CITY PLAN COMMISSION STAFF REPORT

Project Name Promise Place

Docket #6/ Case # Request
.1 - CD-CPC-2022-00084 – Area Plan Amendment.
.2 – CD-CPC-2022-00086 – Rezoning with plan

Plan Conditions

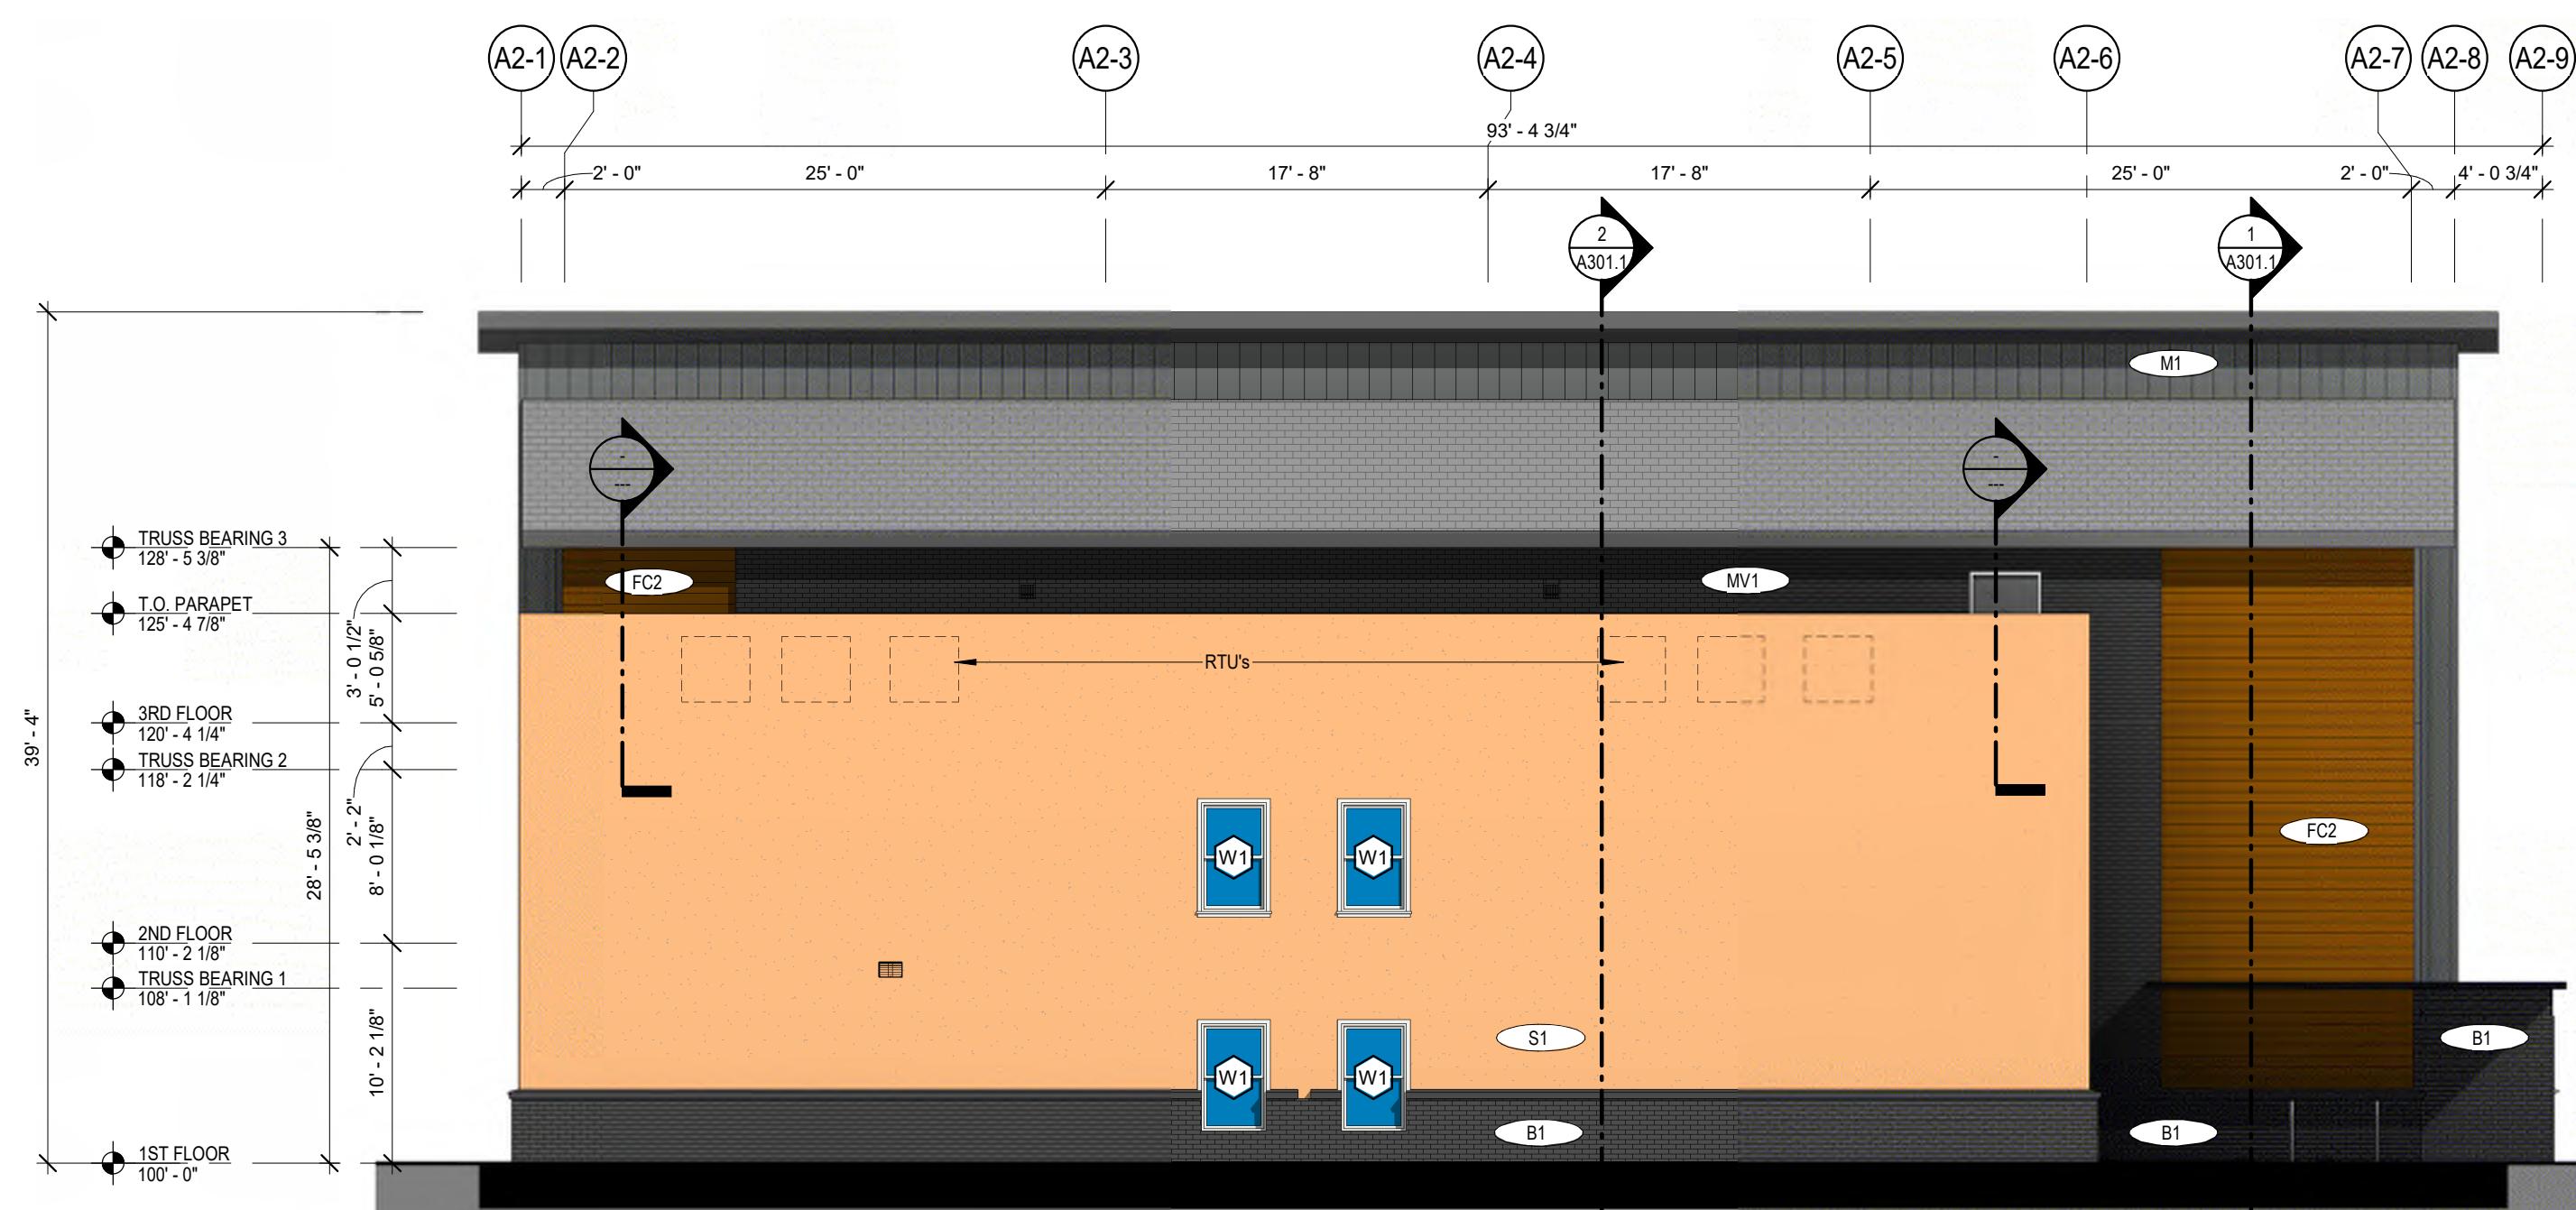
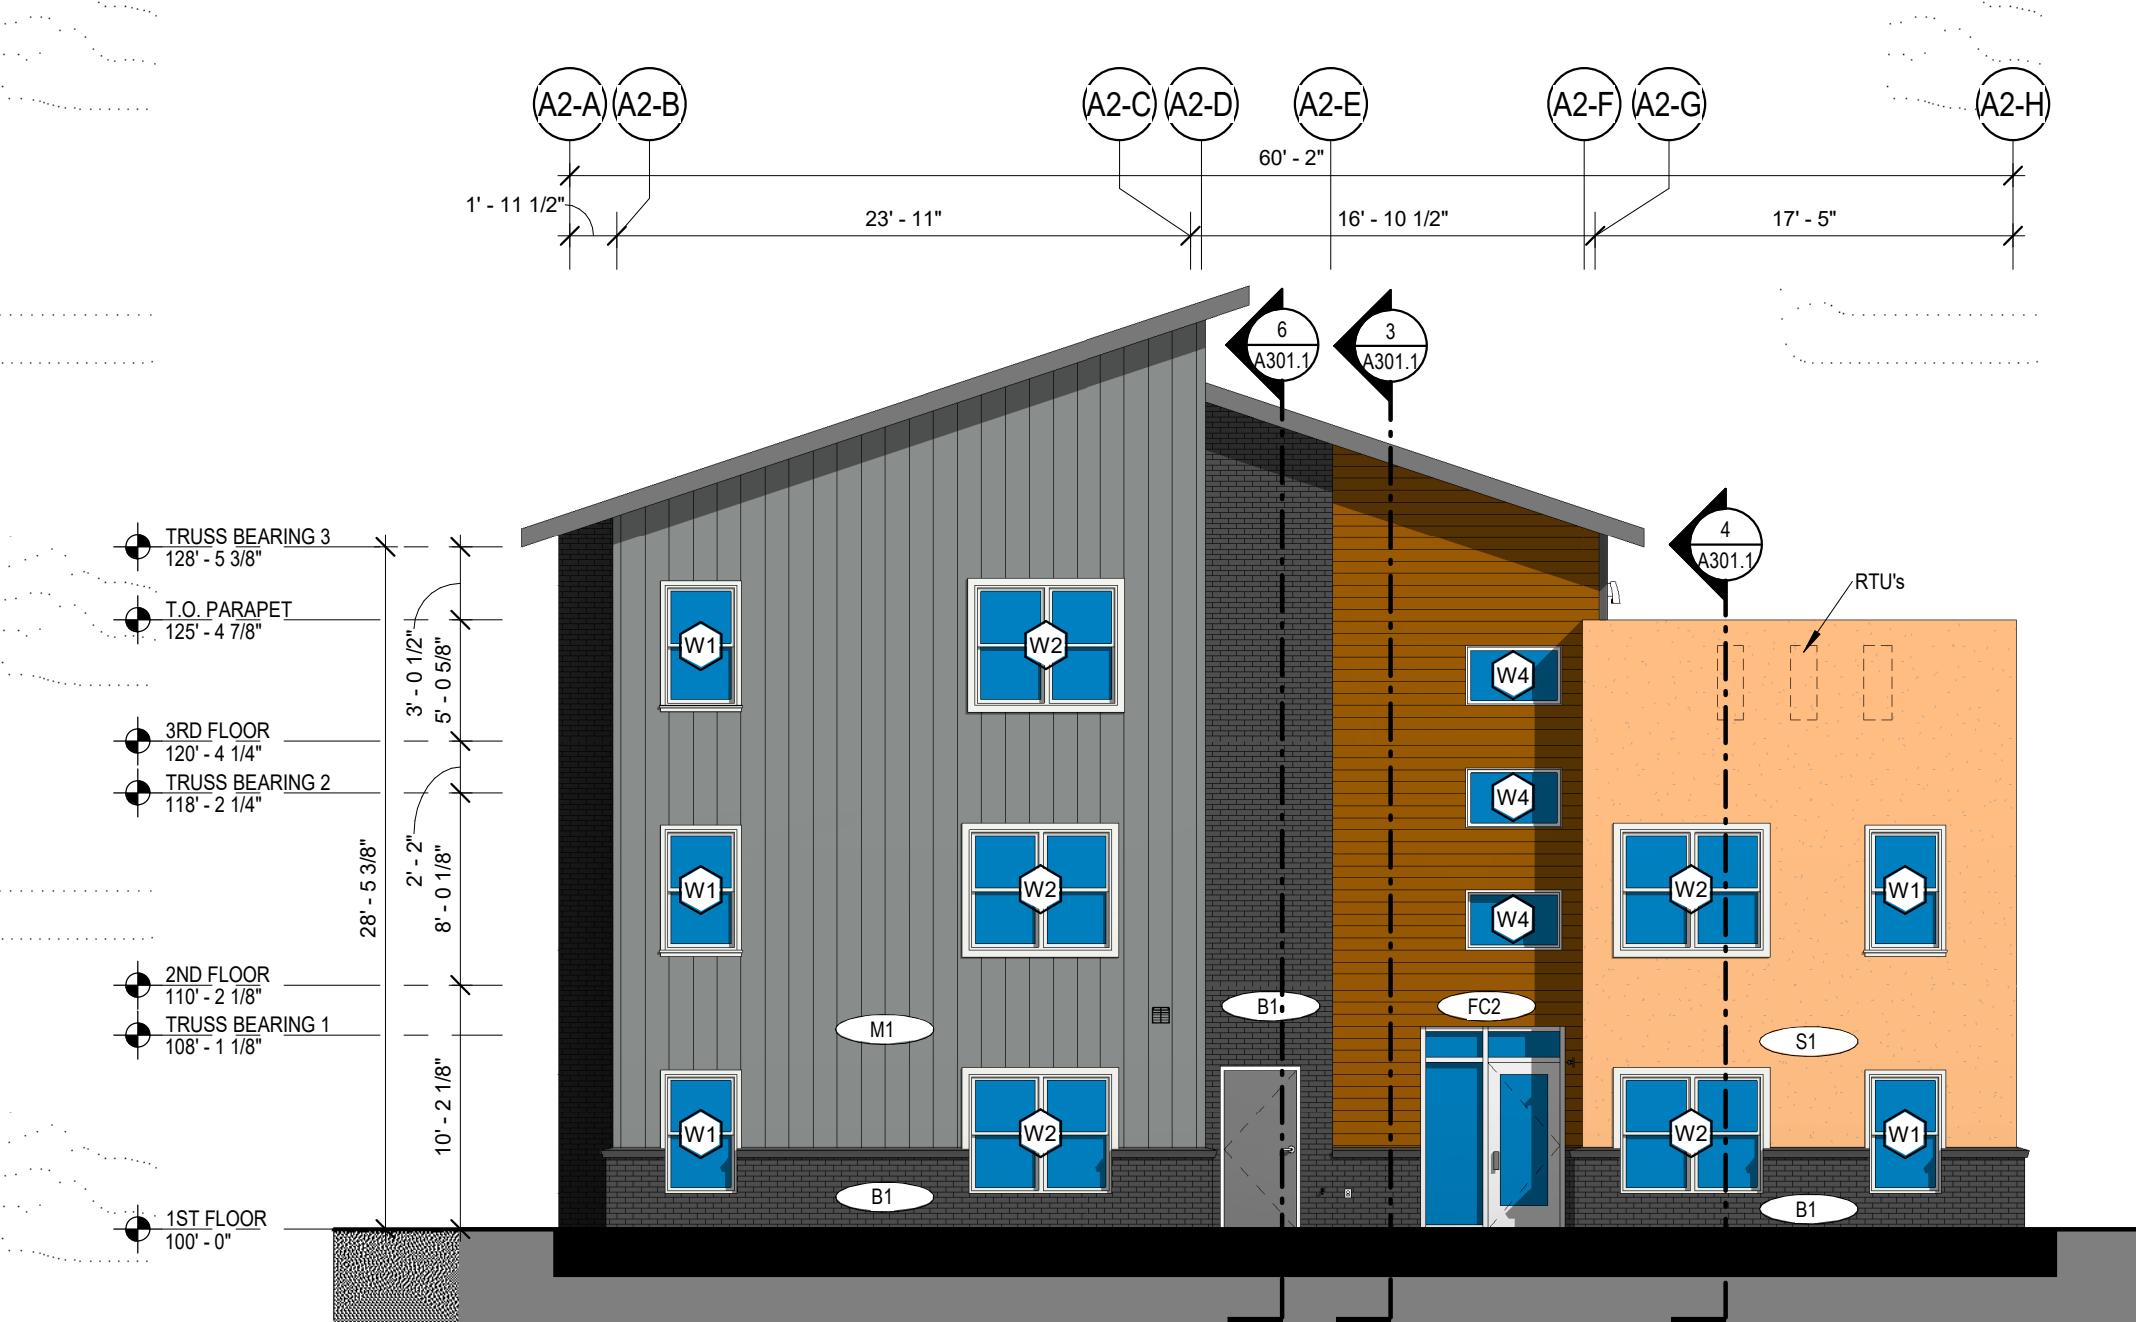
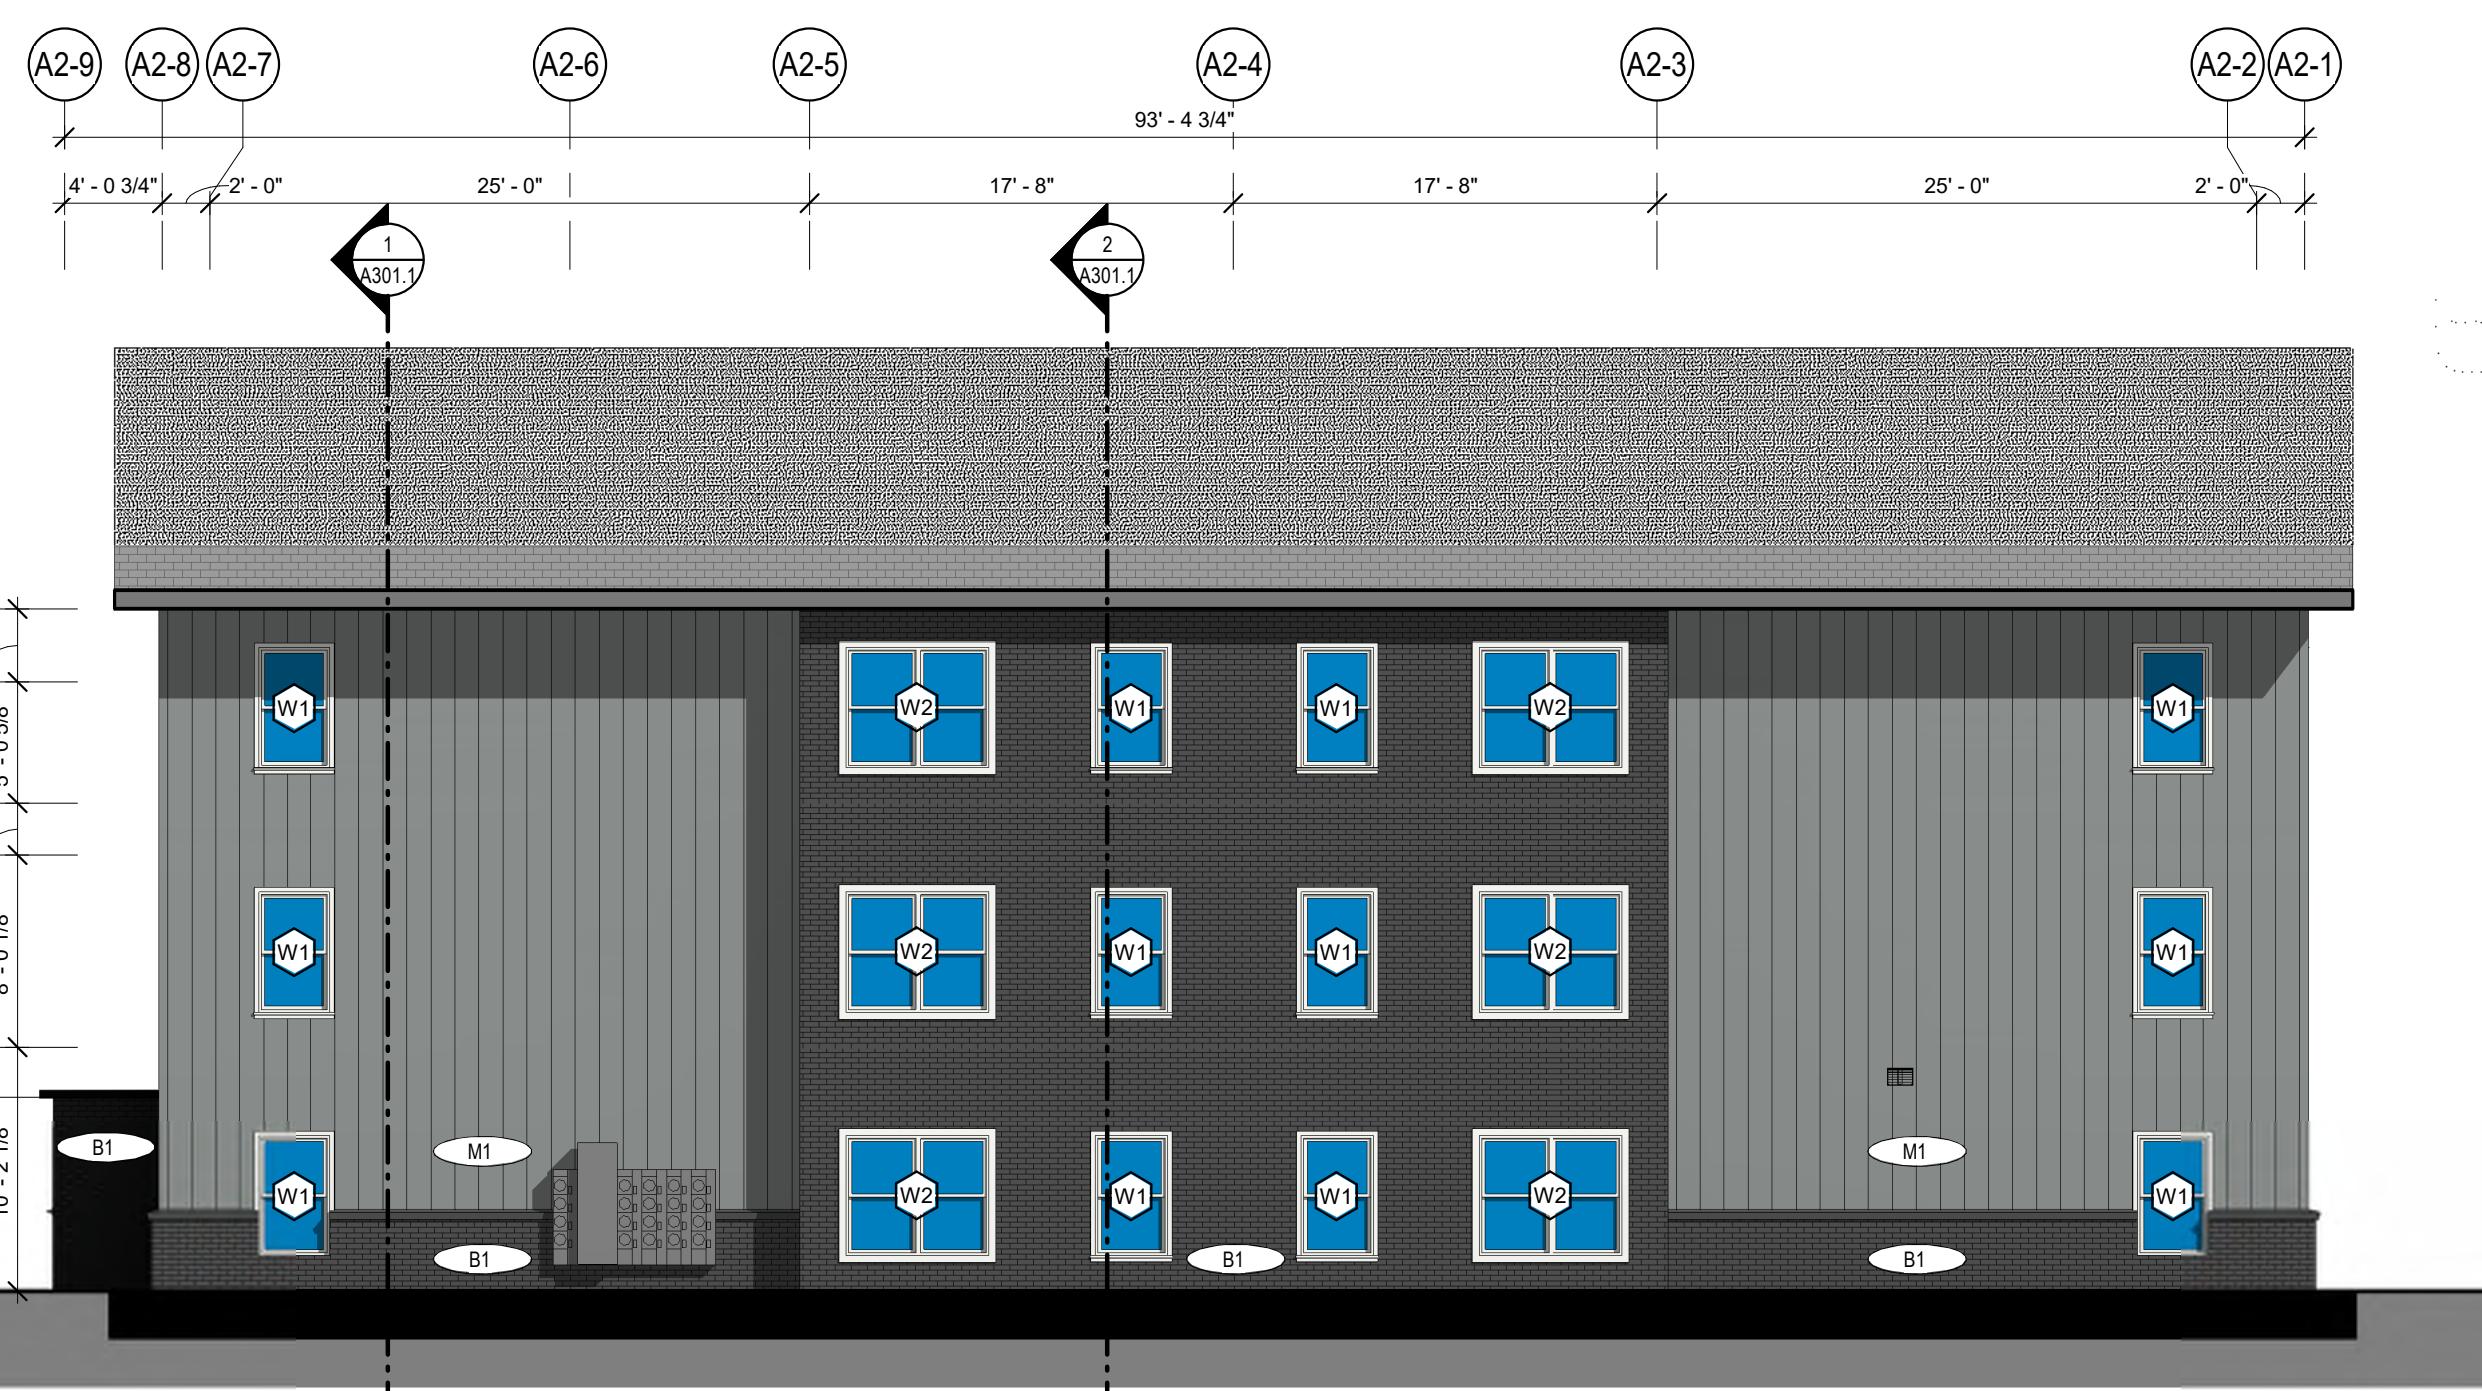
Staff was concerned about the initial building elevation that shows blank walls that face the public street or public sidewalk. Staff recommended that the building elevations be revised to provide a primary entrance for each building facing and directly accessible from the public street and a secondary entrance for each building facing the parking courtyard. Staff also recommended that the pedestrian circulation system that connects residential entrances to adjacent public right-of-way (sidewalks) and to parking area. Other comments require that the developer create open space for amenities for the residents. The applicant has met with staff and submitted the accompanying revised plan addressing most of the attached corrections and conditions. As a result, the corrections will be revised prior to ordinance request.

5. That the developer continue to work with staff to ensure that the building elevations and design meet the requirement of the Zoning and Development Code and the recommendations of the design guidelines of the the Heart of the City Area Plan prior to City Council action.
6. The developer shall submit an affidavit, completed by a landscape architect licensed in the State of Missouri, verifying that all landscaping required of the approved plan has been installed in accordance with the plan and is healthy prior to Certificate of Occupancy.
7. That all signage shall conform to 88-445 and shall require a sign permit prior to installation.
